CD-CPC-2026-00069

241 E Linwood Boulevard
Major Amendment

July 15, 2026

City Plan Commission

1. Site Plan:

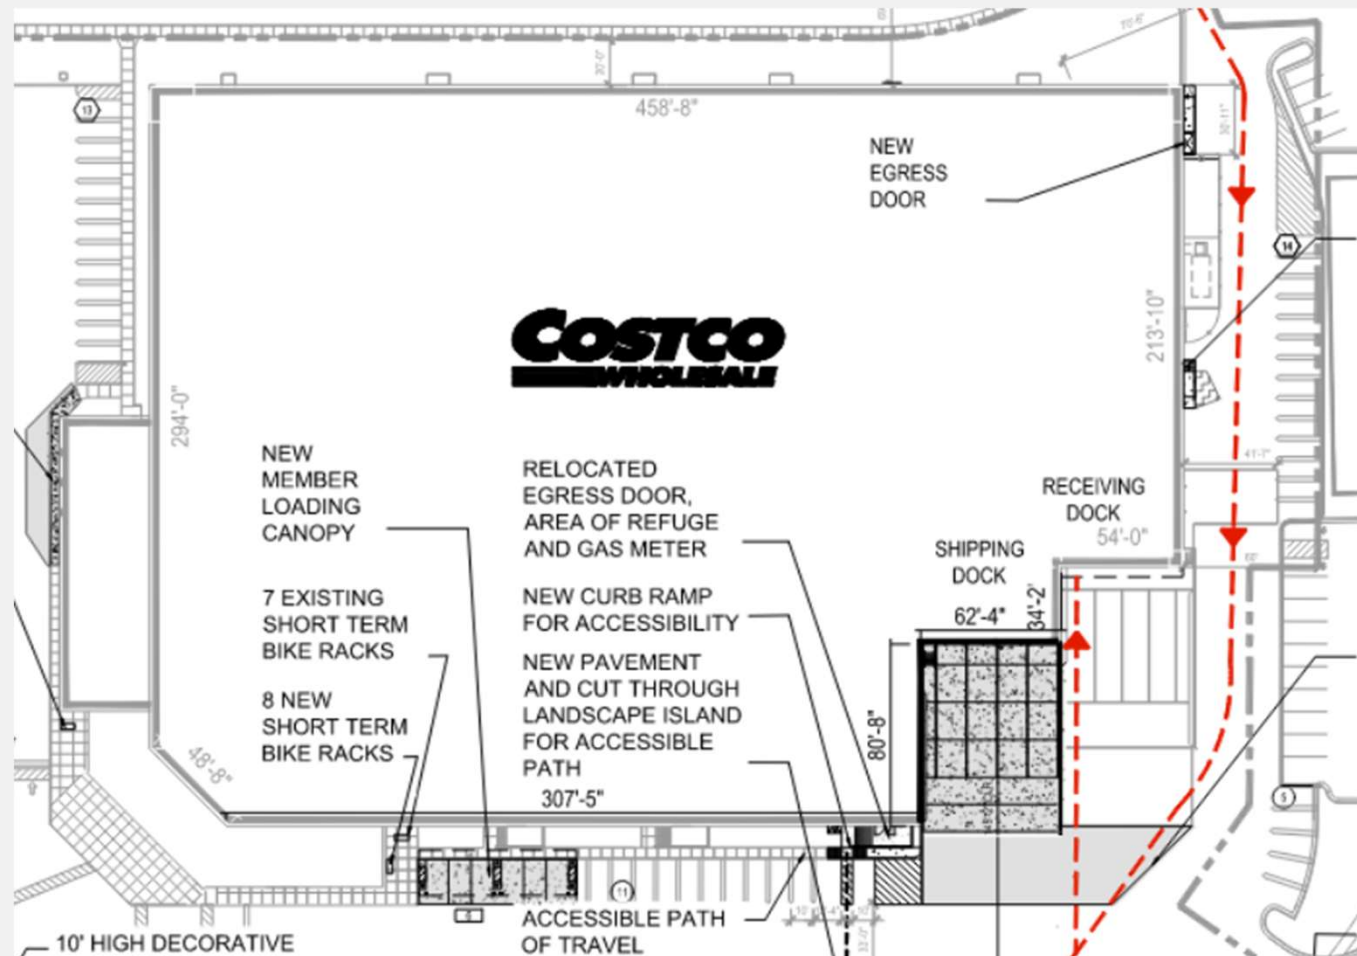
- 88-323-02-D - Any fencing that is visible from the boulevard or parkway shall be 80% transparent and constructed of high quality, permanent materials. Maximum height shall be 6 feet in the rear and 4 feet in the side... Fencing must be of steel, iron, concrete, stucco, stone, brick or other acceptable material.

3. Access Road Median

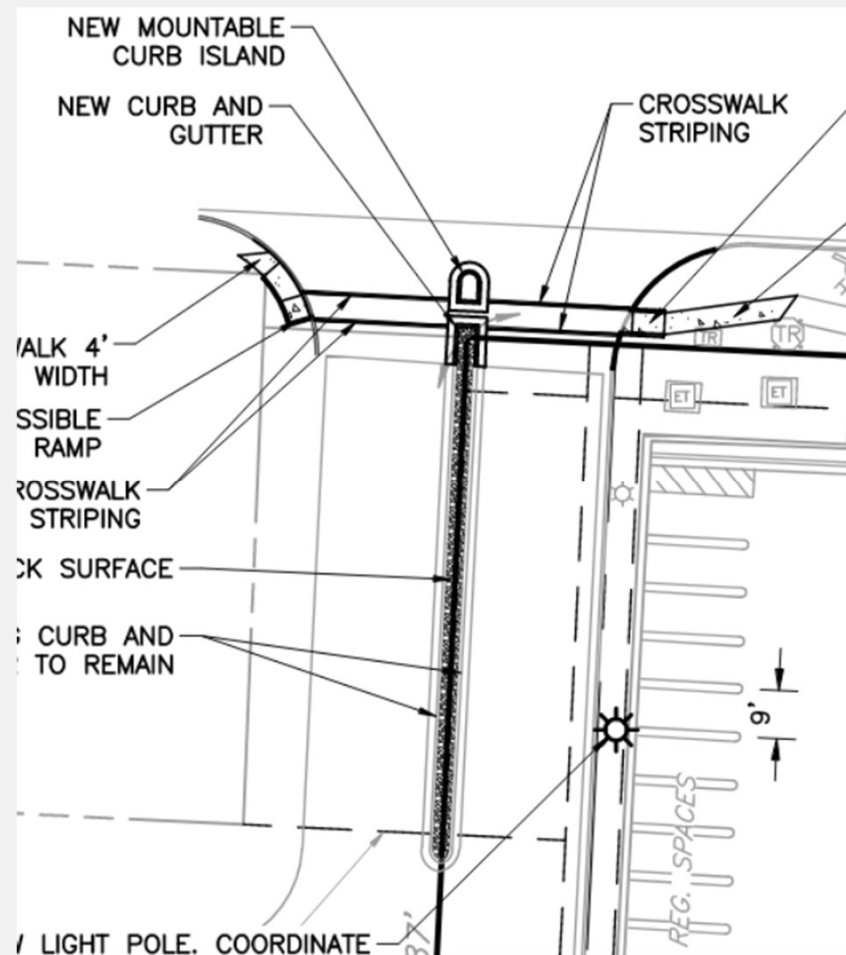
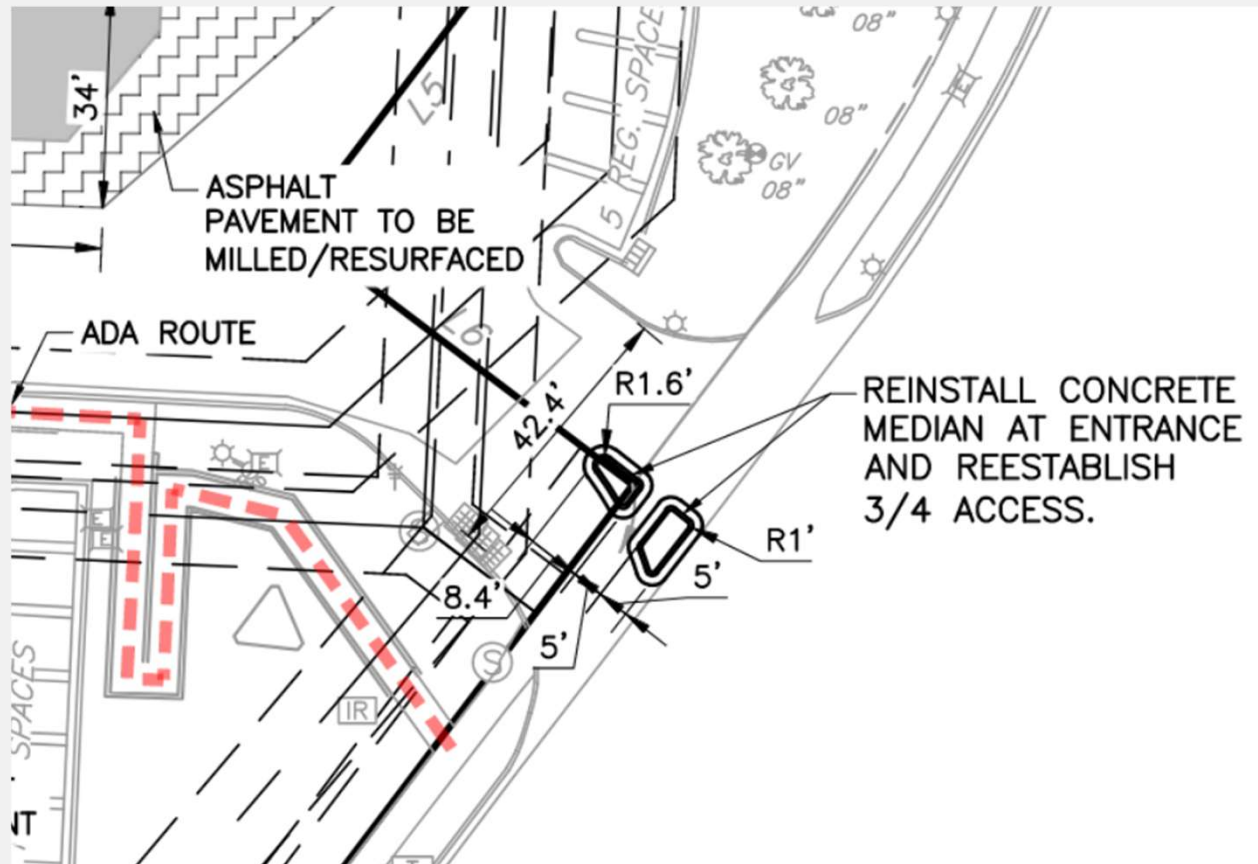
- Includes crosswalk striping
- Uneven rock surface along the southern portion of the median.
- New curb island
